C. Amendments to the drawings:

REMARKS

Fig. 9

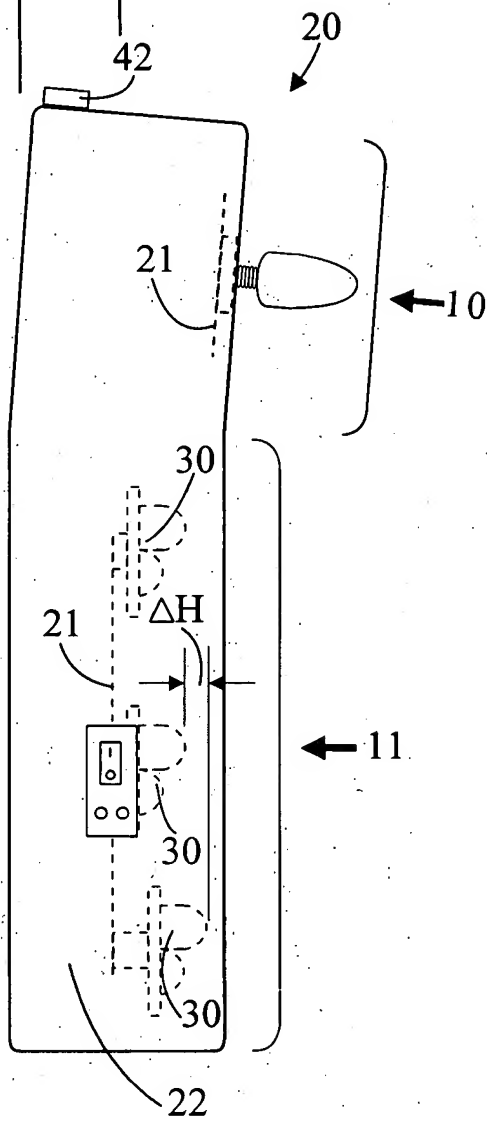
Referring to FIG. 9 and the associated discussion, the lowest pair of back massage heads are raised a distance ΔH from the other two (upper) pairs of back massage heads. This offset feature of the present invention causes the lowest pair of back massage heads to conform to the inward curvature of the user's lower spine and resultantly relaxes muscles around vertebrae 1L through 5L.

Fig. 10

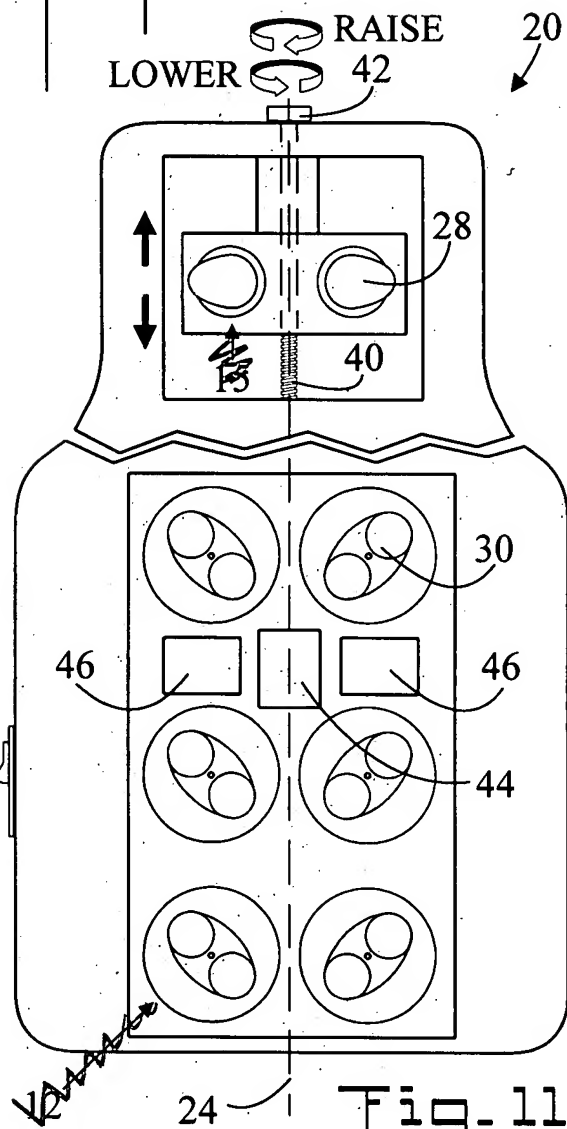
Please replace existing drawing sheet 4/8 with replacement drawing sheet 4/8 included herein. On drawing sheet 4/8, FIG. 10 has been amended to delete reference numeral 15, and FIG. 11 has been amended to delete reference numeral 12.

The drawings are objected to as failing to comply with 37 CFR 1.84(p)(5) because they include the following reference character(s) not mentioned in the description: 12 and 15. . .

The Applicant has amended FIGs. 10 and 11 of drawing sheet 4/8 to remove reference numerals 15 and 12 respectively. Both replacement and annotated sheets 4/8 are included herein.

Fig. 16

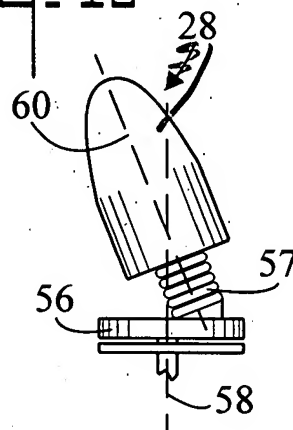
Please replace existing drawing sheet 5/8 with replacement drawings sheet 5/8 included herein. On drawing sheet 5/8, FIGs. 15, 16, and 17 have been amended to modify reference numeral 28.

Referring to FIGs. 16 and 17, it is noted that in the present invention the central axis 60 of the neck massage head 28 outwardly projects from rotating unit 56 toward rotational axis 58. That is, central axis 60 angles toward rotational axis 58. In fact, the two axes actually cross within the body of neck massage head 28.

FIGs. 15-17 on drawing sheet 5/8 have been amended to correct the placement of reference numeral 28 (neck massage head). Both replacement and annotated sheet 4/8 are included herein.
